# 1995 - 1996 Corvette: Service Bulletin: Delayed Engagement (Replace Pump Cover Assembly)

**Subject:** Delayed Engagement (Replace Pump Cover Assembly)

**Bulletin Number:** 67-71-48

FIGURE 1. - HYDRA-MATIC 4L60-E TRANSMISSION IDENTIFICATION  
INFORMATION

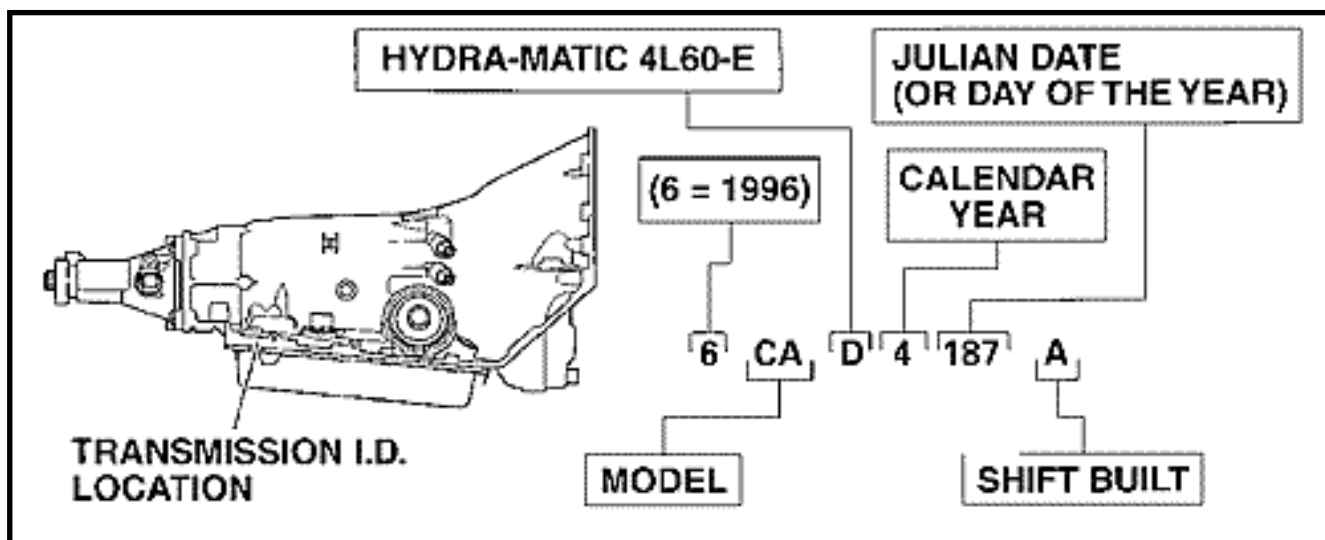
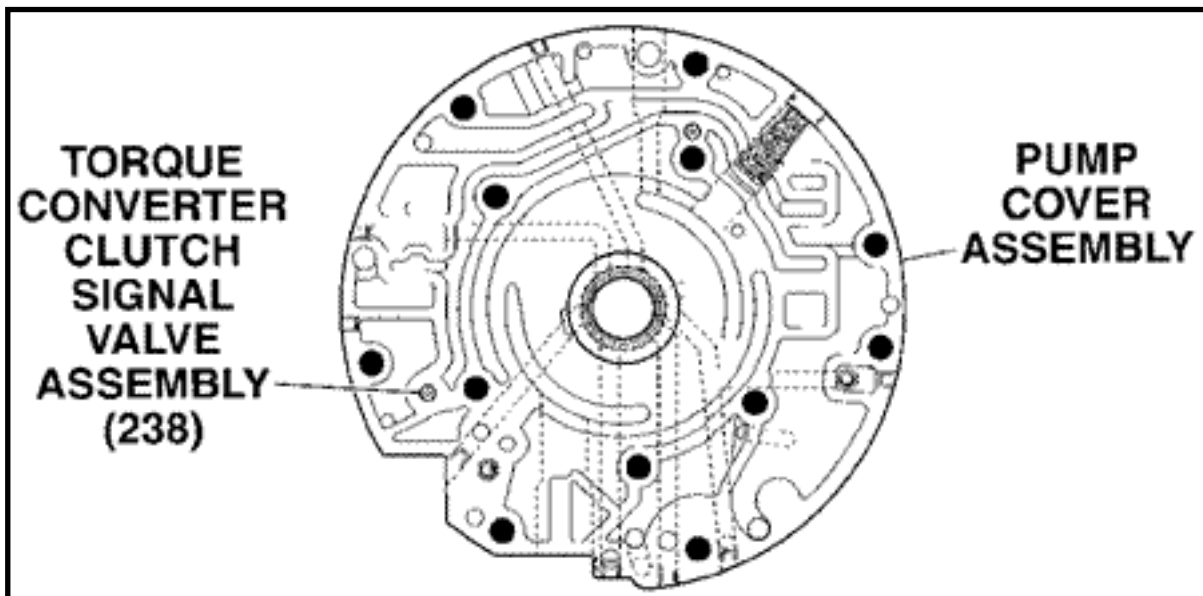
(FIGURES 1 AND 2) SOME OWNERS OF THE ABOVE MODELS, WITH A HYDRA-MATIC 4L60-E TRANSMISSION (BUILT BEFORE APRIL 29, 1996/JULIAN DATE 6120), MAY EXPERIENCE SOME DELAYED ENGAGEMENT WHEN VEHICLE IS NOT USED FOR MORE THAN 48 HOURS.

FIGURE 3. - TORQUE CONVERTER CLUTCH SIGNAL VALVE ASSEMBLY  
LOCATION

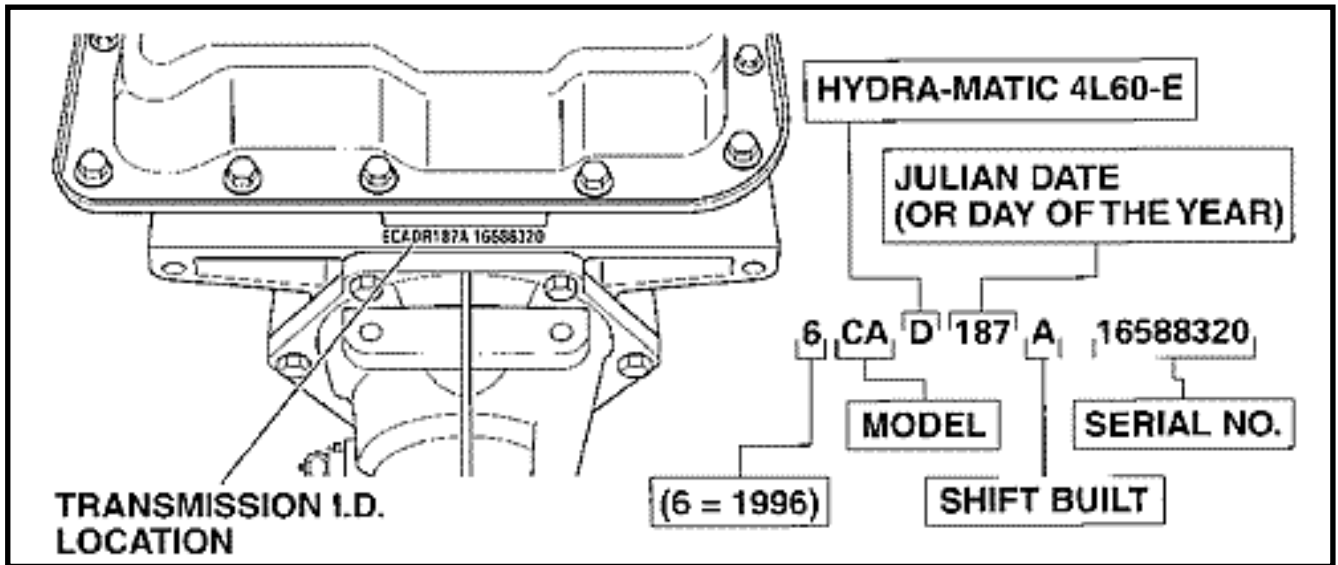
TORQUE CONVERTER FLUID LEVEL LOW DUE TO FLUID DRAIN DOWN.

(FIGURE 3) REPLACE PUMP COVER ASSEMBLY WITH THE NEW TCC SIGNAL VALVE ASSEMBLY.
